Appendix 4: Updated Plans Submitted as part of s73 Application

Schedule of Approved Plans to Identify those being replaced as part of the s73 Application
 [Copies of all replacement plans provided as part of this Appendix and immediately after this Schedule]

Project: 653 York Potash
 Drawing Title: Woodrigh Mine Proposed Site and Block Plan
 Scale: 1:1500 @ A0
 Drawn: [Signature]
 Date: 28 September 2012

Drawn:	653-AP-0005
Status:	Issue (Not for Construction)
Revision:	4

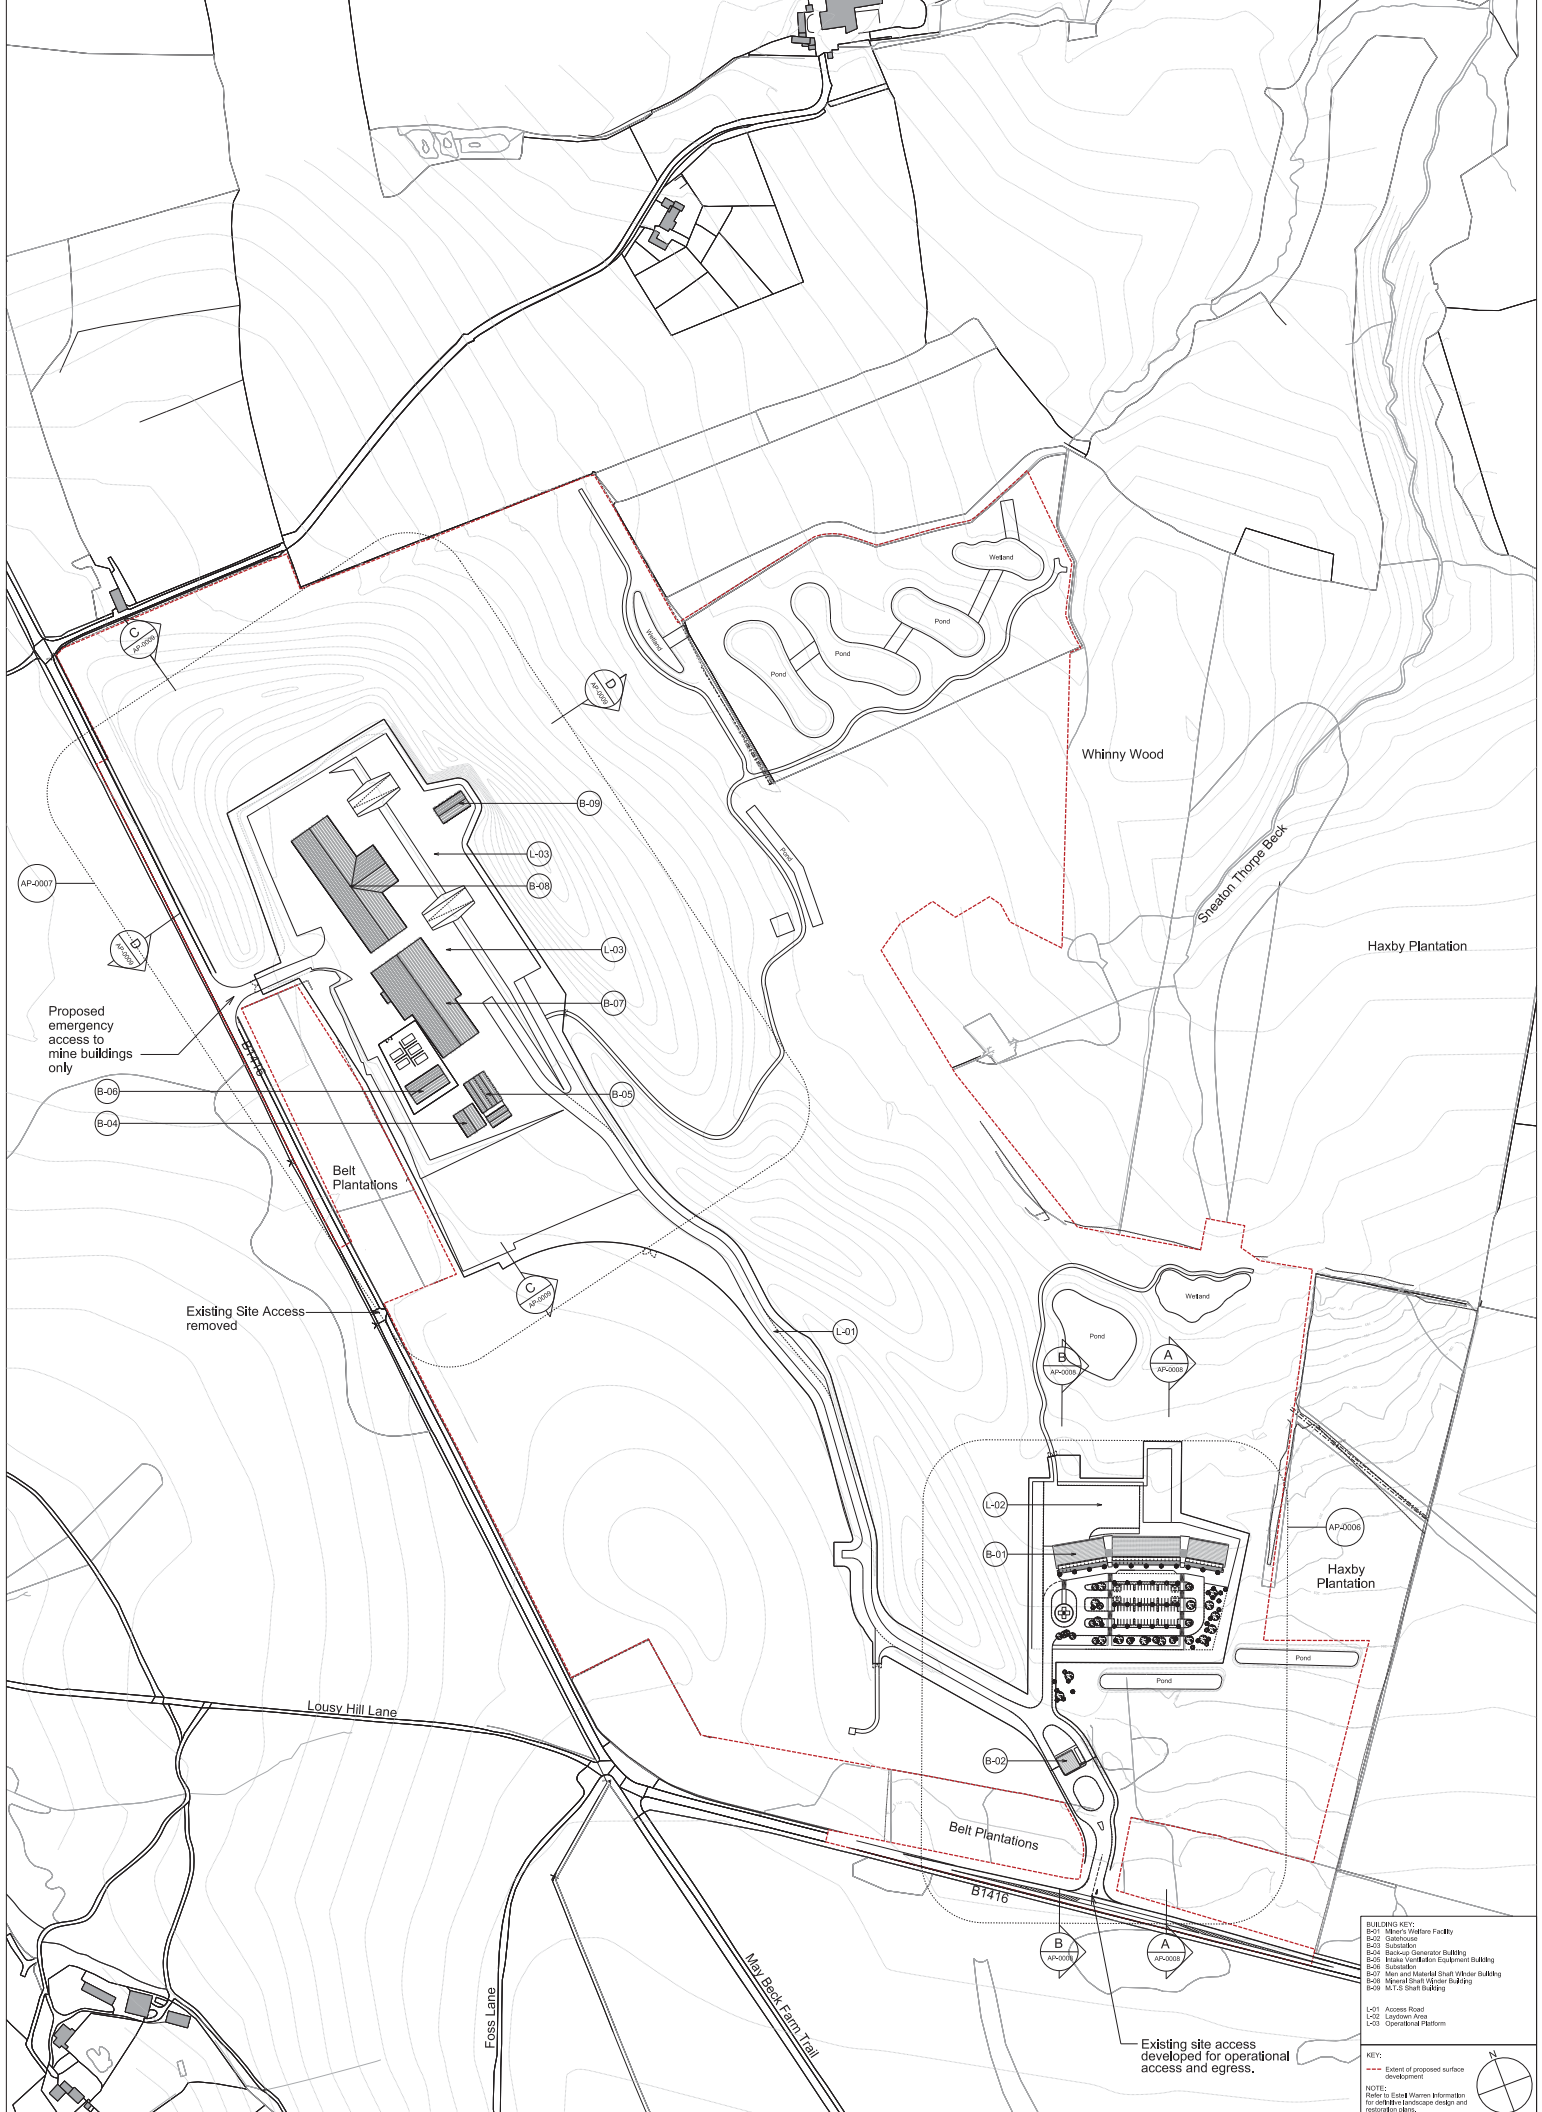
Rev	Date	By	Check	Notes
1	2017.06.27	PL	PL	Final design
2	2017.06.27	PL	PL	Updated to incorporate with NPPC Schedule of Changes for the SEI submission.
3	2017.06.27	PL	PL	Updated to incorporate with Section 23 applications - M.T.S. shed location.
4	2017.06.27	PL	PL	Updated for Section 23 Application June 2017 in accordance with Planning Review dated 26.05.17.
5	2017.06.27	PL	PL	Updated for Section 23 Application June 2017 in accordance with comments dated 27.05.17.
